Subject: **WATER AND WASTEWATER CAPACITY AVAILABILITY LETTER**
Beach Boy Plaza, DRC Case No. R18011
401 South Fort Lauderdale Beach Boulevard, Fort Lauderdale

City of Fort Lauderdale
Public Works Department
Water and Wastewater Capacity Analysis

Beach Boy Plaza, DRC Case No. R18011
401 South Fort Lauderdale Beach Boulevard, Fort Lauderdale

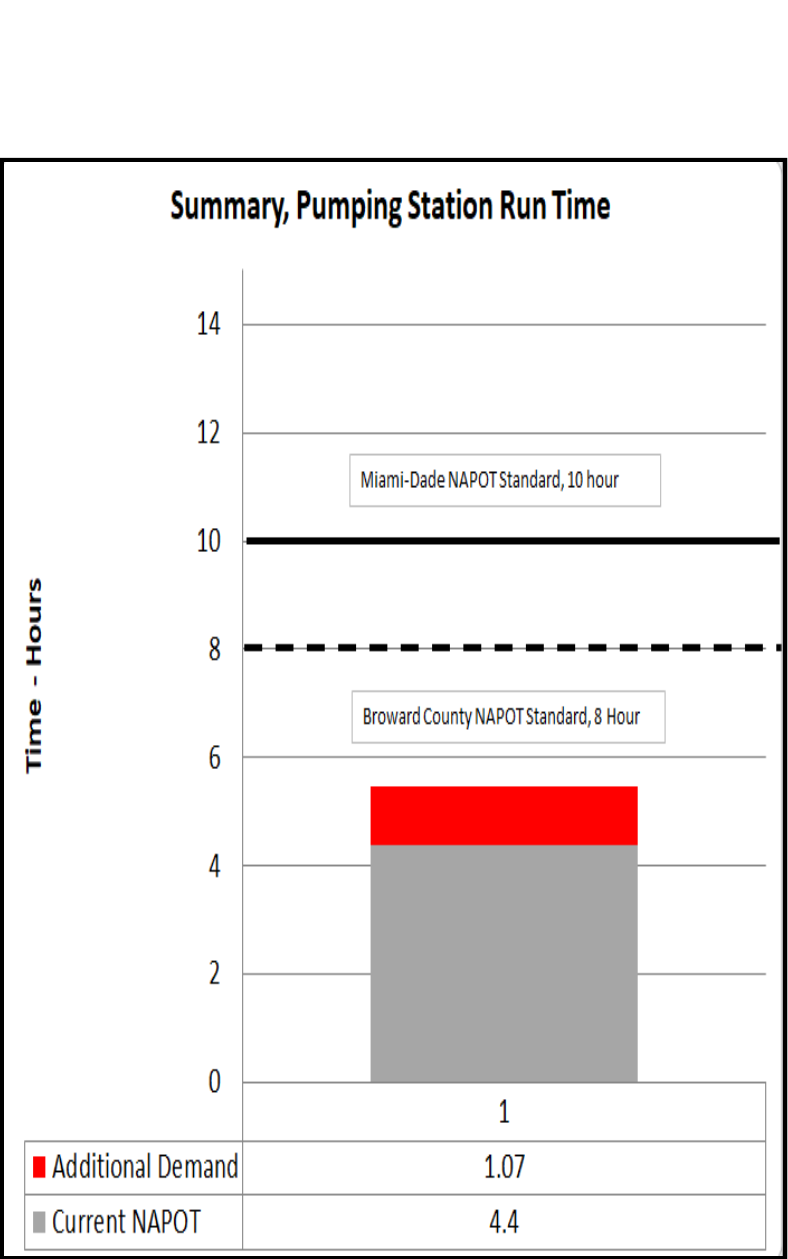
Water: The site is currently served by a 6-inch water main located along Seabreeze Boulevard which connects to a 12-inch water main along Las Olas Boulevard. See Figure 1.

Evaluation of impact on existing distribution pipe (flow & capacity): According to the site plan the applicant is proposing to utilize the 6-inch water main on Seabreeze Boulevard. The InfoWater hydraulic model was analyzed to determine the impact of this project on the existing 6-inch water. The existing water main has capacity to serve the project.

Recommended Water Infrastructure Improvements: No improvements required.
